Univent Replacement at Farley Elementary School
Univent Replacement at Willow Grove Elementary School
MSA File No. 42052

SED No. 50-02-01-06-0-003-011
SED No. 50-02-01-06-0-030-016

Re: ADDENDUM NO. 1

1 FIRST FLOOR PLAN INSTALLATION - 2
SCALE: 1/16" = 1' - 0"

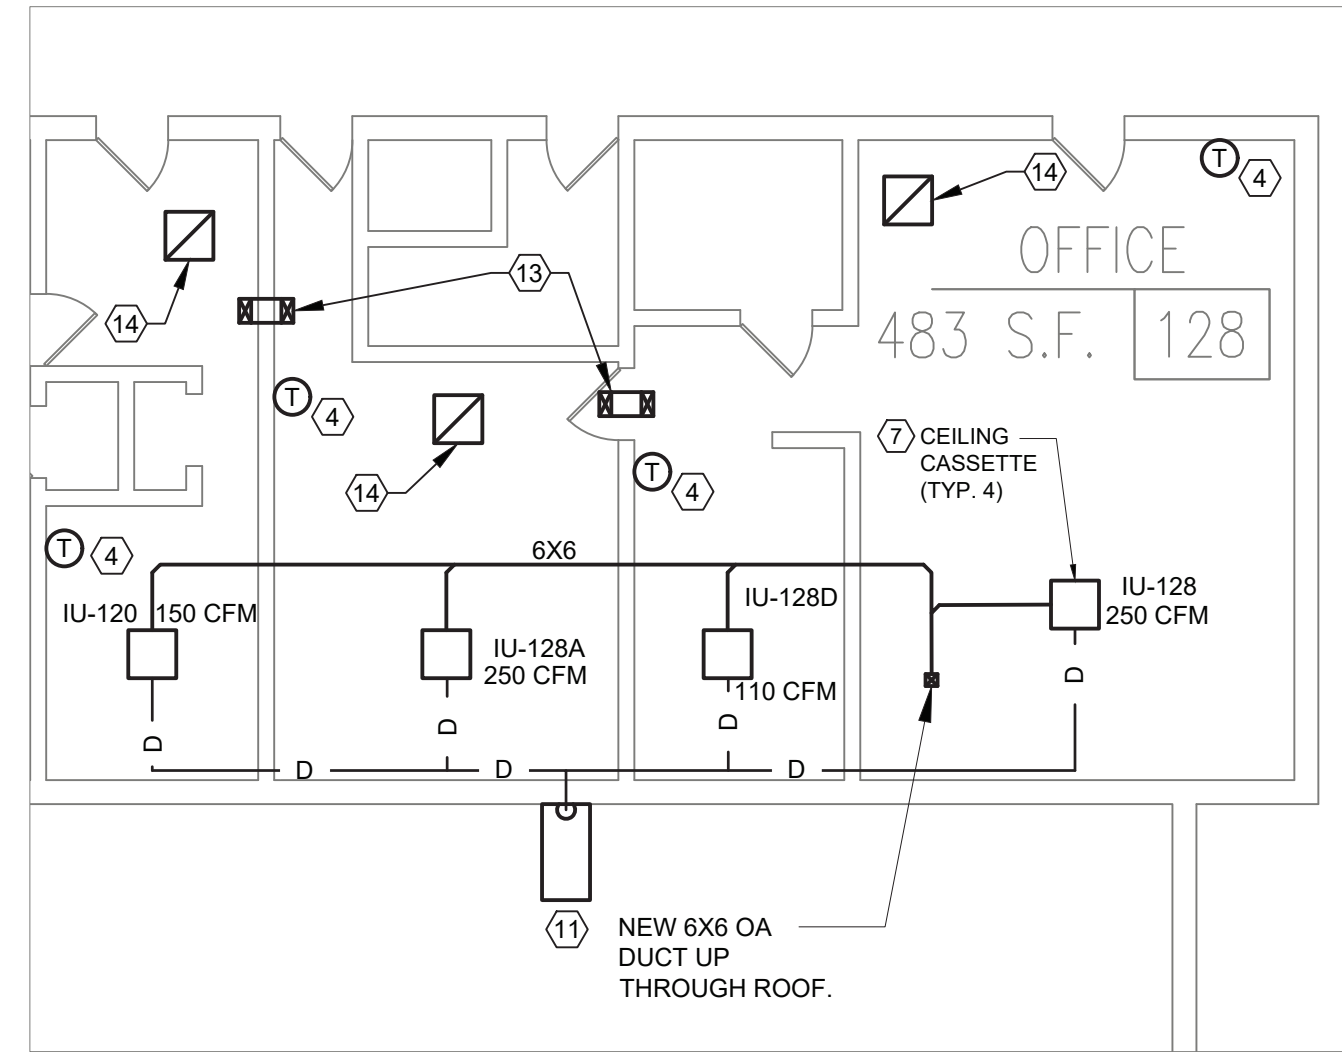
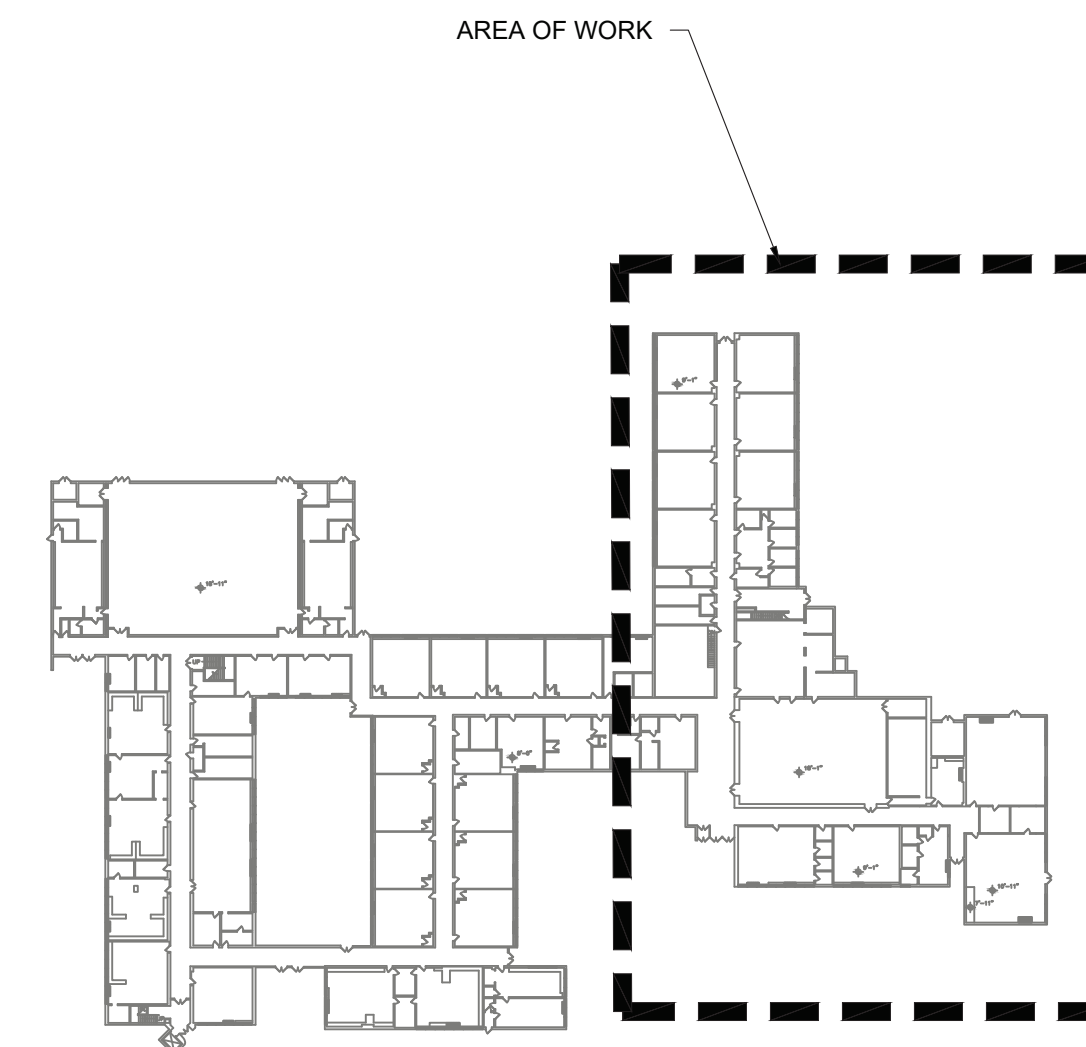
- 3) Attached are drawings regarding phasing for UV Replacement at Farley Elementary School. The drawings included are labeled with the following: CONSTRUCTION SEQUENCE PLAN.

2 ROOF PART PLAN UNDER HP-2
SCALE: 1/2" = 1'-0"

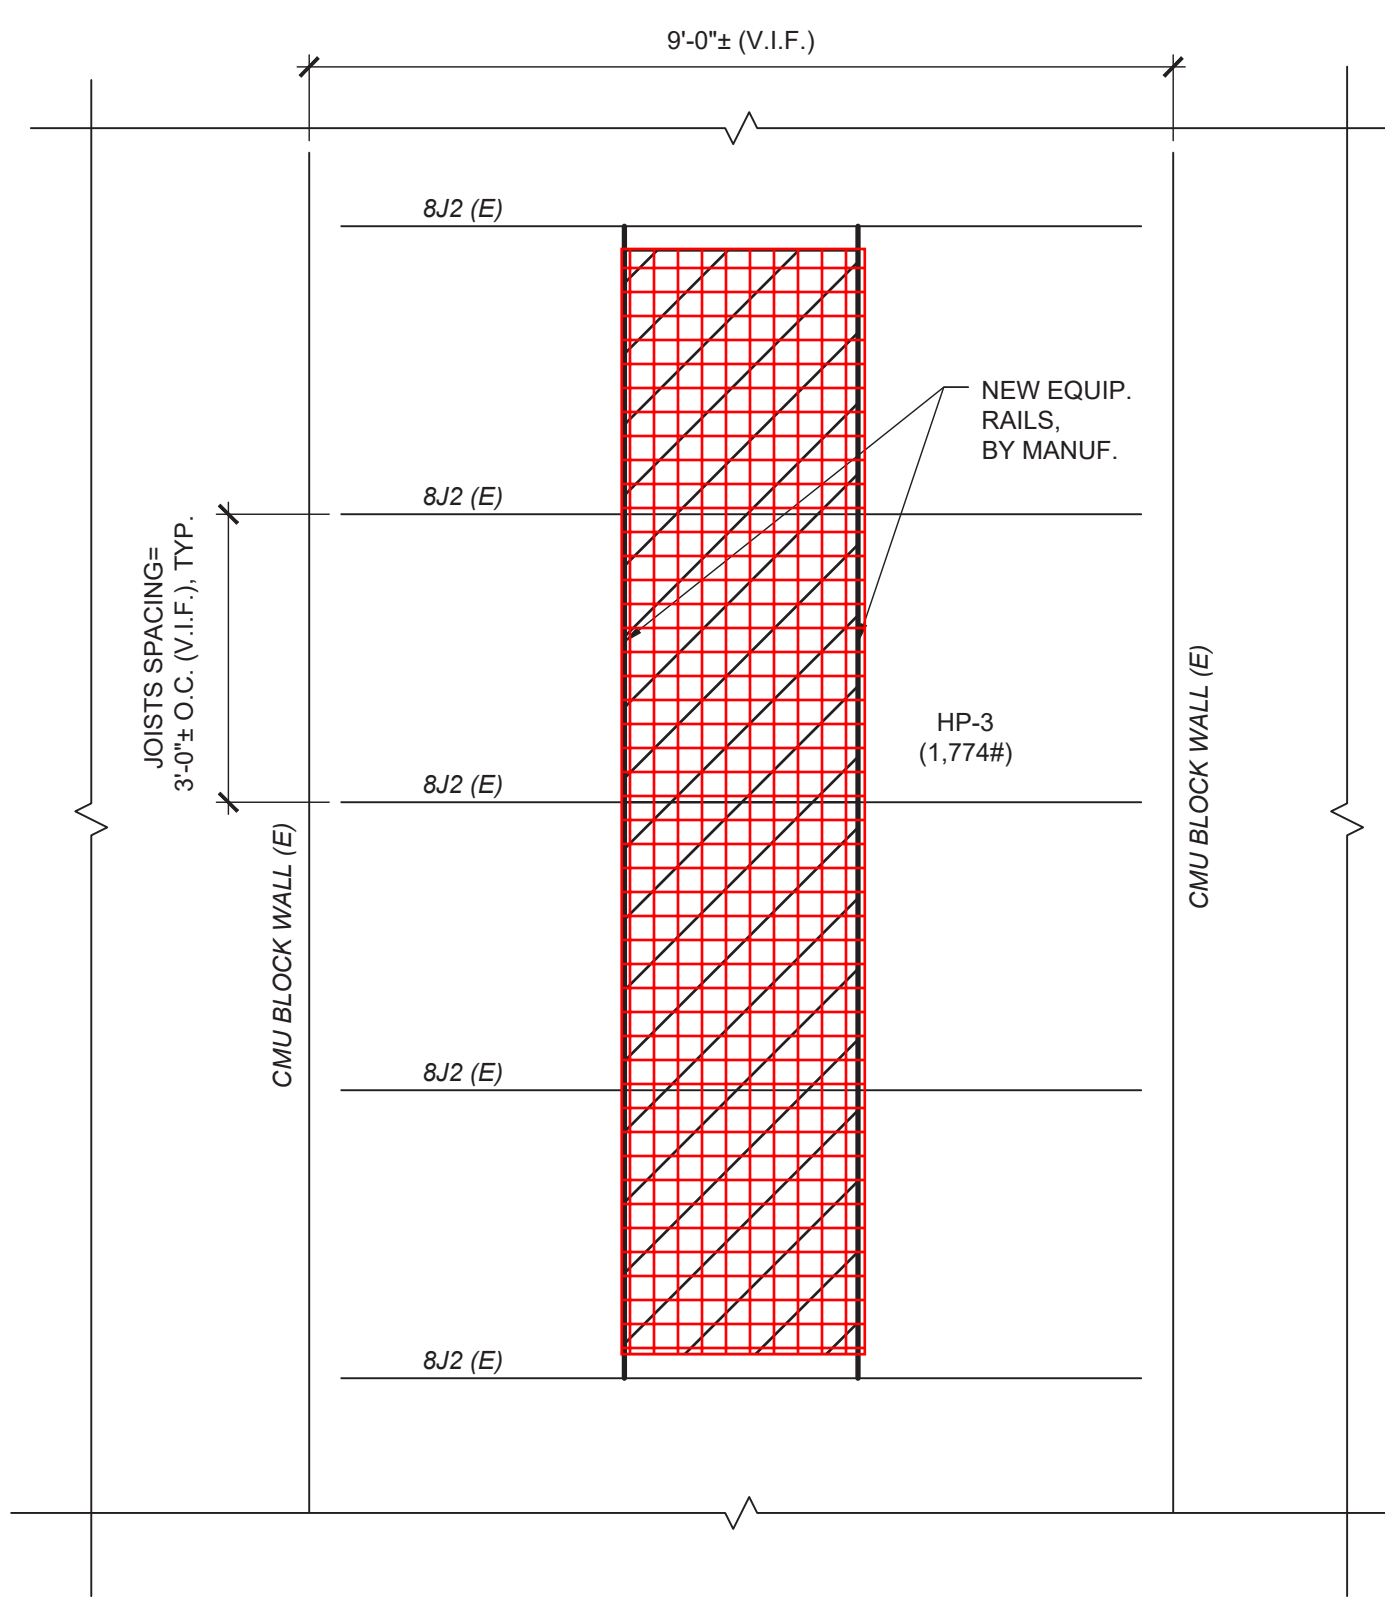
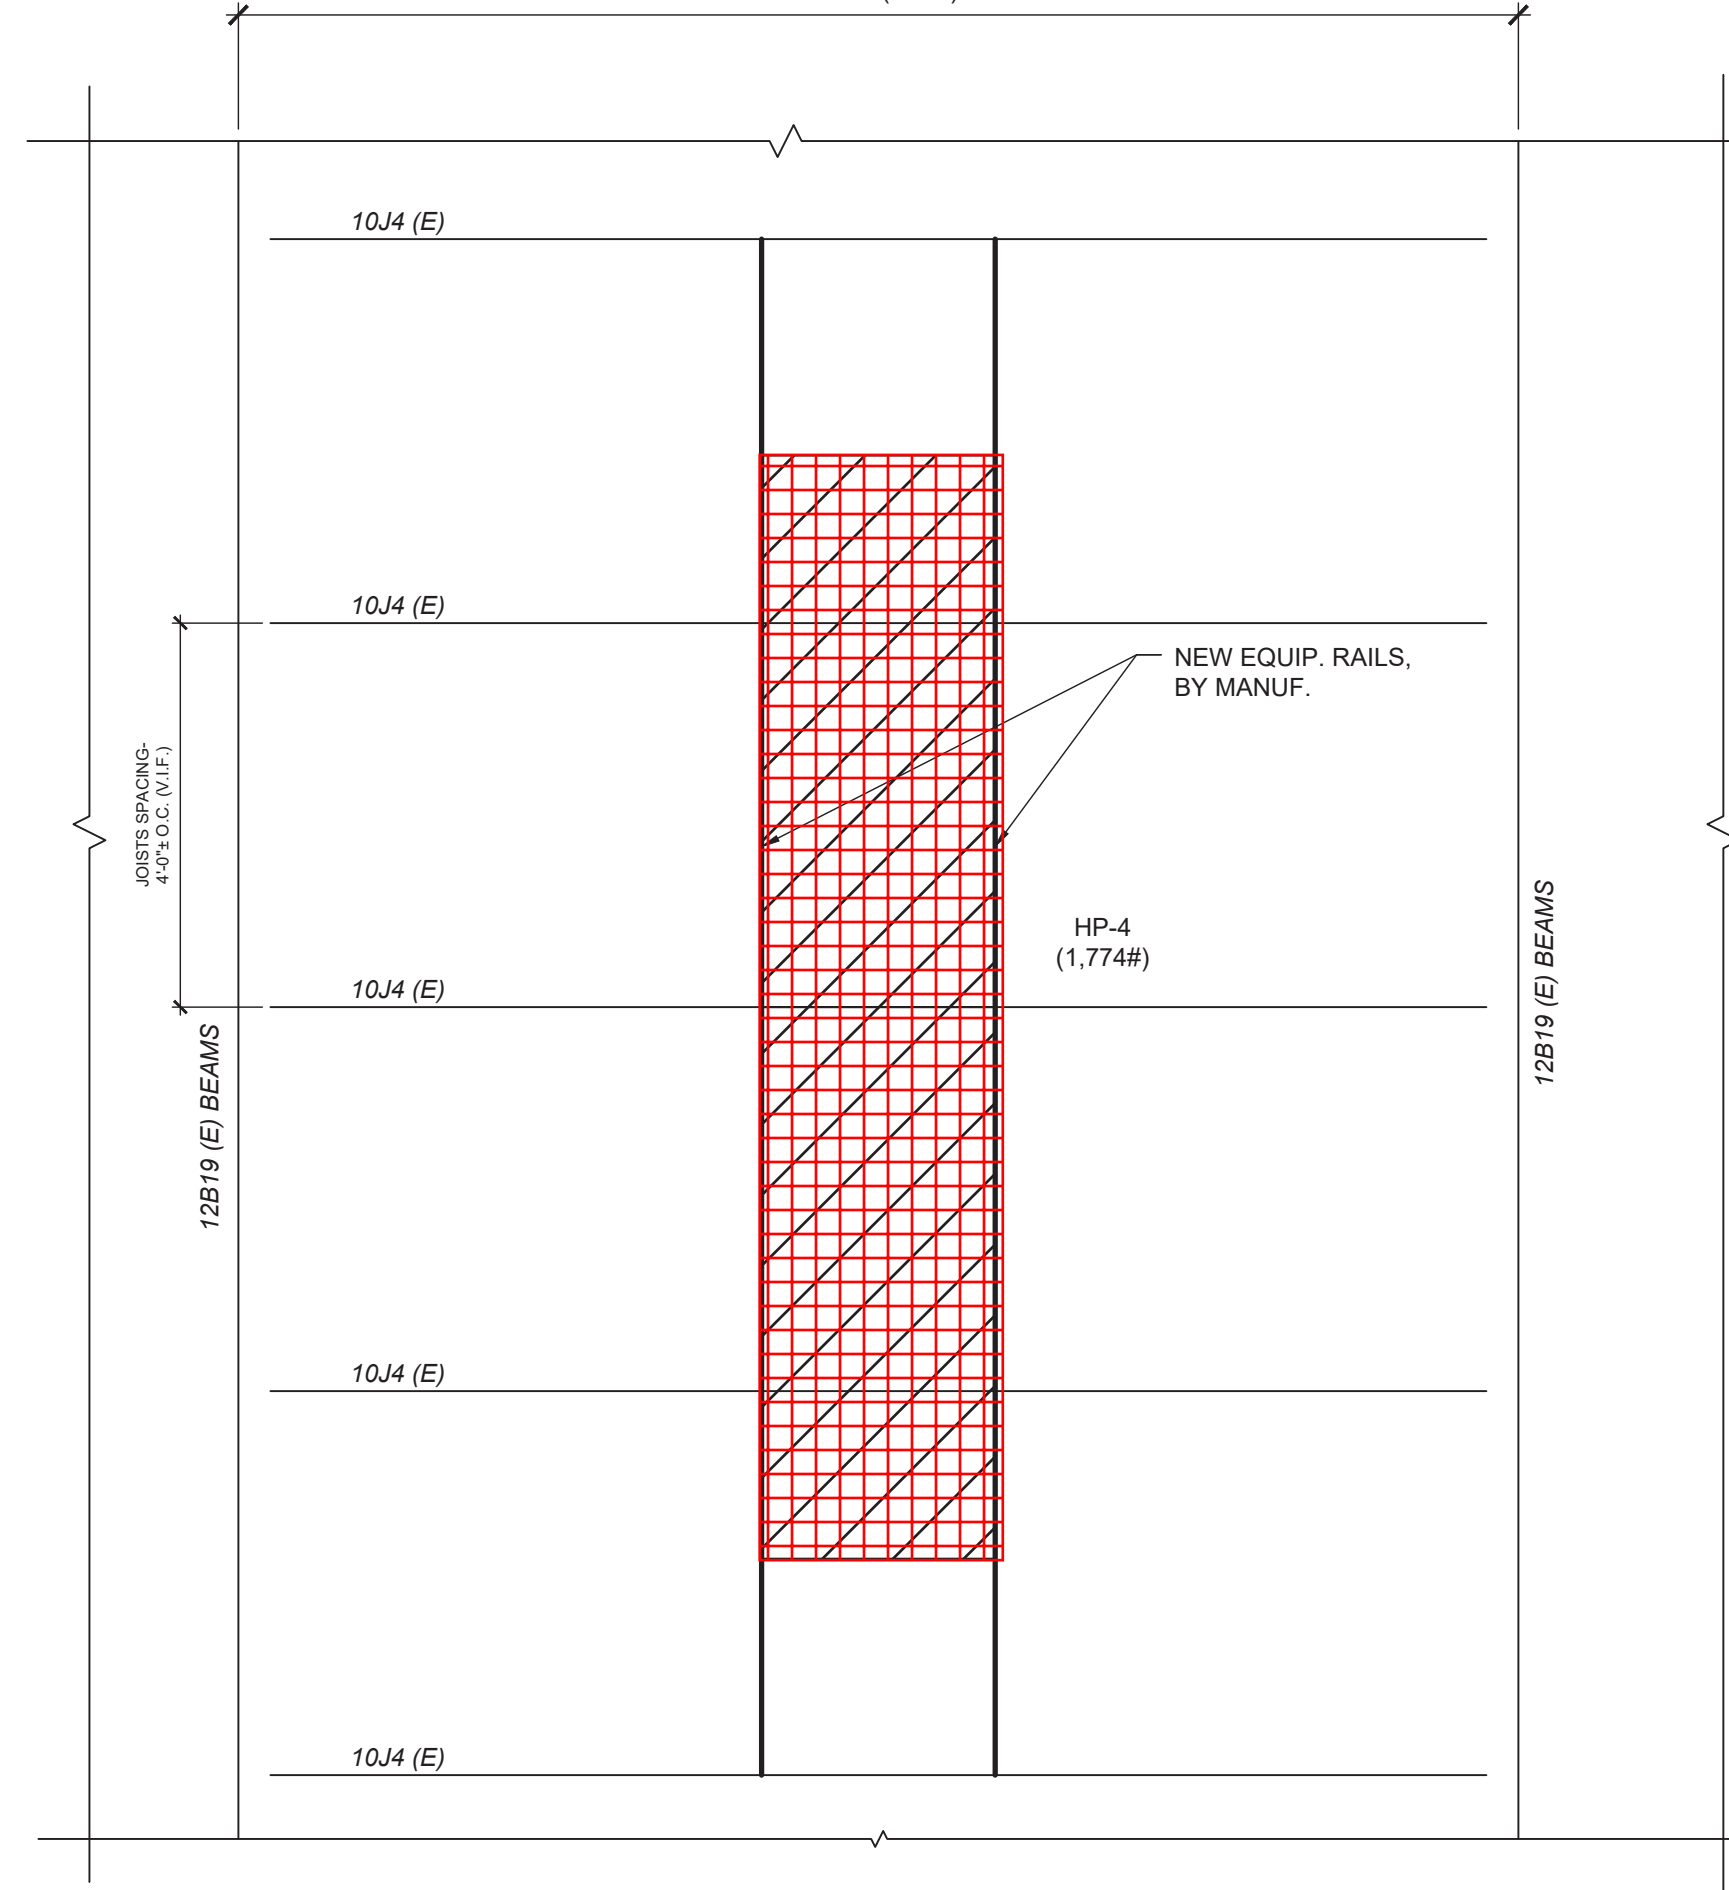
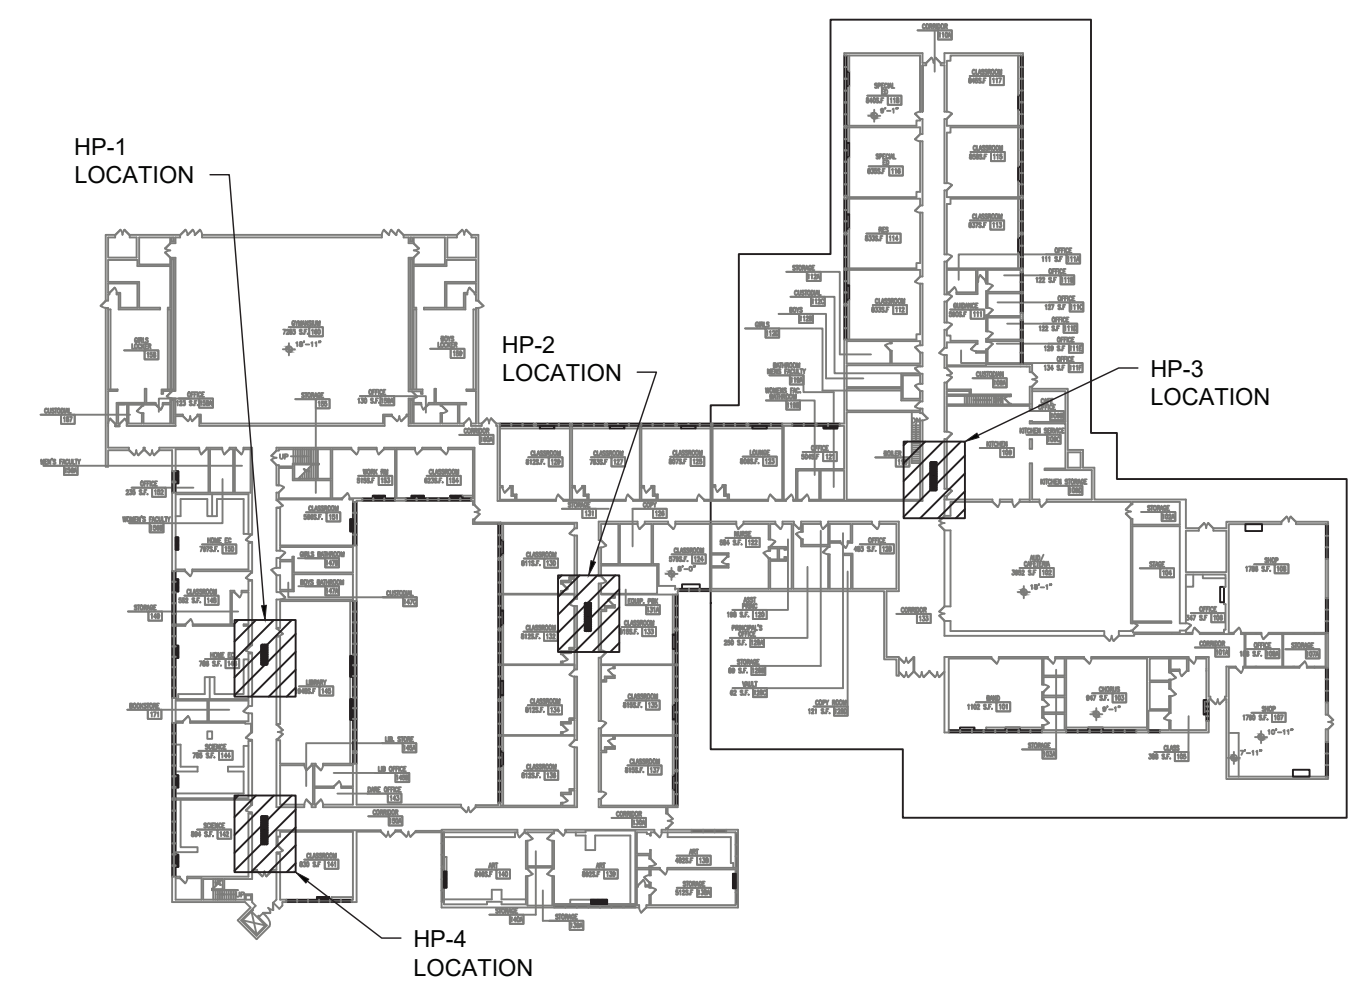
- 16) Drawing FES-S-102 has been revised dated, 11-09-23, see attached. Revisions include updates to the structural roof plans.
- 17) Drawing FES-M-003 has been revised dated, 11-09-23, see attached. Revisions include updates to the unit ventilator schedule and the ductless heat pump outdoor unit schedule.
